**CITY OF GAINESVILLE PLANNING DIVISION  
SUMMARY OF COMMENTS**

**Petition Number: 119SUB-98 DB**                      **Reviewed by: Gene G. Francis**  
**Development Review Board Meeting: July 9, 1998**  
**Project Name/Description: Breckenridge Cluster Subdivision Design Plat**

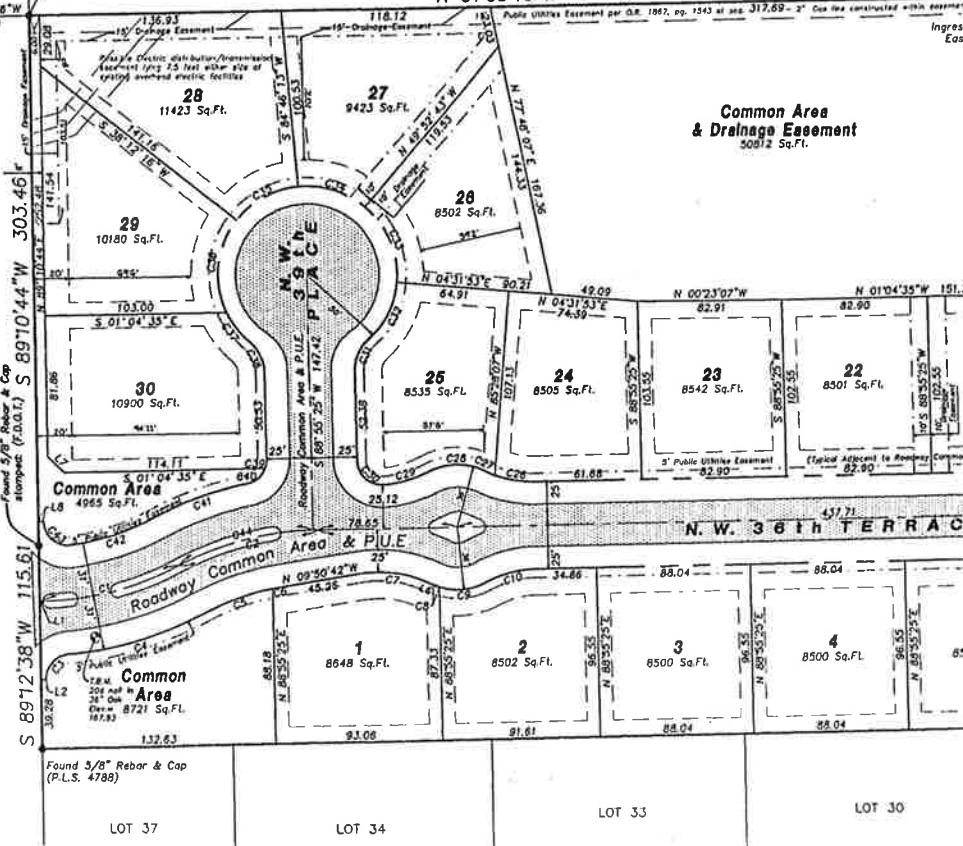
1. The rear building setback lines located along the east, west and north property lines must be revised to match the abutting 20 foot setbacks as per code.

2. Lots 28, 29, and 30, backing up to the "Arterial" 39th Avenue, should have their rear setback line drawn at 35 feet from the 39th Avenue right-of-way line or 29 feet from the rear property line. Generally the code requires a 50 rear building setback next to arterials or collectors.

3. Please indicate that there shall be no access from Lots 28, 29, and 30 onto 39th Avenue. I realize that there is to be a wall along the right-of-way but that would not prevent a gate from being installed in the wall.

4. The wall should be drawn on the "General Layout" plan as a continuation of the entrance wall.
5. On the final plat, the petitioner should only indicate what the building setbacks "shall be" except as noted. The petitioner should not write what they are being changed from. That could always change in the future.

6. The information about the Capri cluster subdivisions needs to be revised. The "Public Utilities Easement" needs to be indicated.

7. The Planning Division is requesting that the petitioner provide a 5 foot wide sidewalk along at least one side of the private north-south road leading into the subdivision. This request is based upon City Commission guidance and good planning practice. This sidewalk would be consistent with the sidewalk requested for the "Palm Grove" subdivision being developed approximately 10 blocks to the east.

8. In addition, planning staff is requesting that the petitioner provide/allow for pedestrian access to and from Capri Cluster Subdivision through the "Public Utilities Easement" located in the northeast corner of the subdivision.

No direct access to N.W. 39th Avenue  
from Lots 28, 29 and 30.

BRICK WALL SHALL BE CONSTRUCTED IN 6" WIRE COMMON AREA  
TO SEPARATE LOTS 28, 29, AND 30 FROM N.W. 39th AVENUE
